Fw: Objection: AWDM/0080/24 and AWDM/0012/24| Proposed end-of-terrace two storey house.

From: Faye Buckner [redacted]
Sent: 19 February 2024 21:38
To: planning@adur-worthing.gov.uk <planning@adur-worthing.gov.uk>; [redacted]
Subject: Objection: AWDM/0080/24 | Proposed end-of-terrace two storey house.

Diagrams taken from AWDM/0080/24:

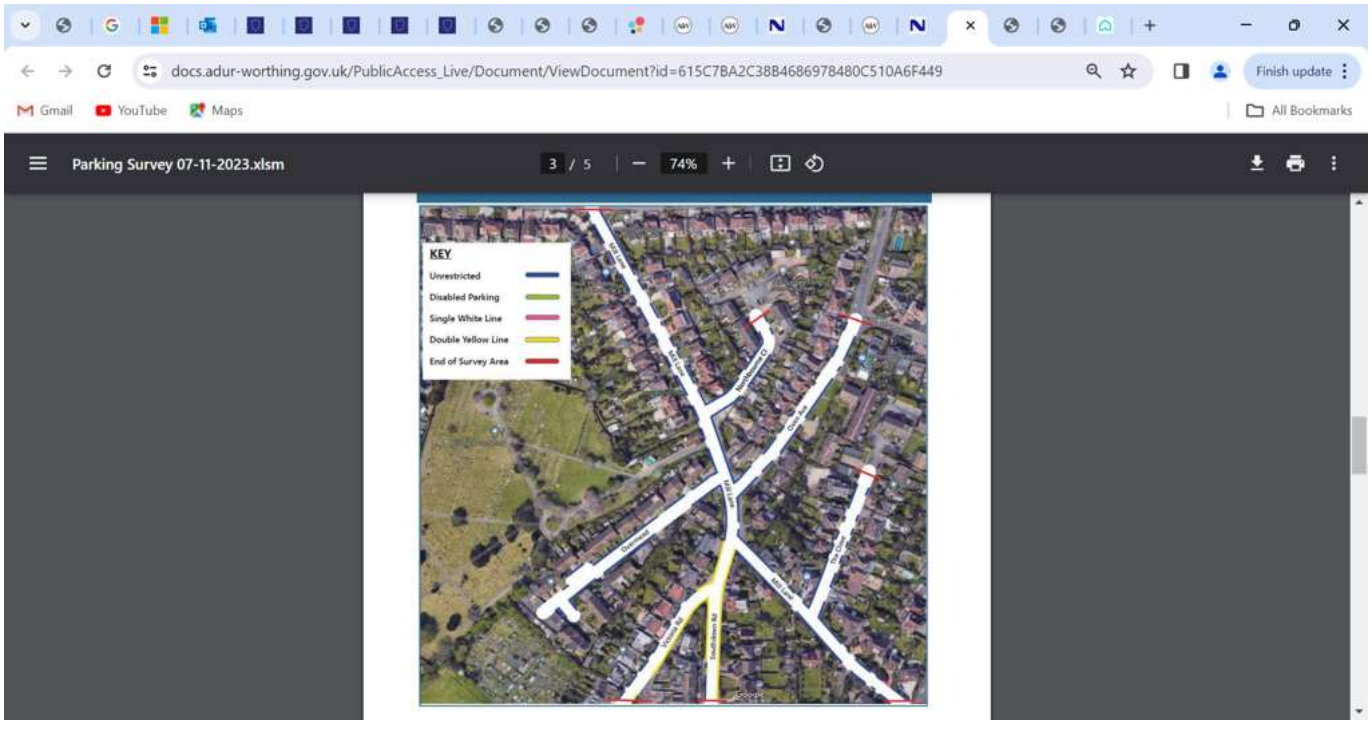
The 'Parking Survey' submitted as an attempt to undermine resident's concerns around parking should not be relied upon. It is unclear and contradictory in nature which brings into question it's accuracy. As an example, the report highlighted sections below are excluded from the final available parking calculation. Including parking around corners/junctions, where parking on both sides would cause an obstruction and where drop kerbs are present.

The 'Survey Area' satellite image below, shows gaps where dropped kerbs have not been included in the calculation per the ‘Sections of road excluded in parking capacity calculation’ section. Contrary to the same section the image indicates that both sides of roads remain highlighted in many areas where parking on both sides would cause major traffic obstruction, including but not limited to Overmead, Northborne Close, The Close and Oxen Avenue. The same is also apparent around hazardous junctions, where the image indicates parking has been included in the capacity caculation.

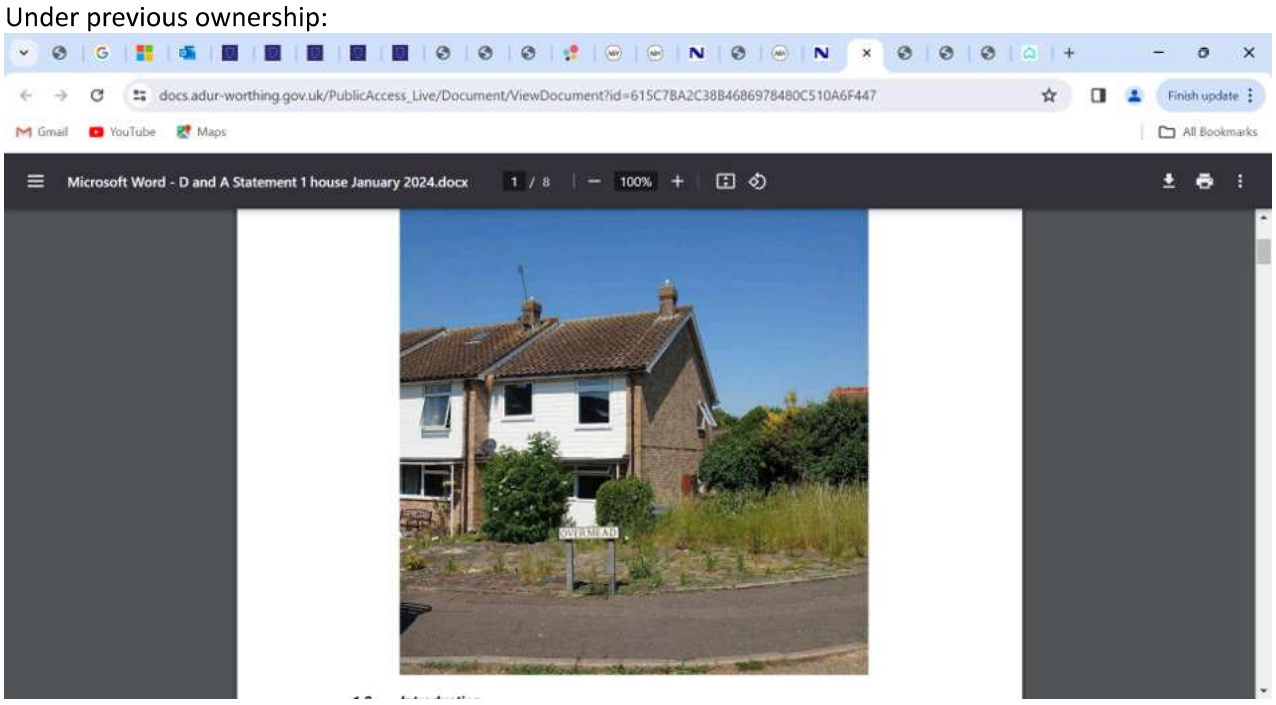
5. The DESIGN AND ACCESS STATEMENT proposes a leafy mixed hedge along the boundary. The local authority should be aware that the property did have this (as shown in the first image on the DESIGN & ACCESS STATEMENT) but it was cut down by the new owner. Any proposed replacement would take years to reach the heights and density alluded to in the plans

Under previous ownership:

Current ownership:
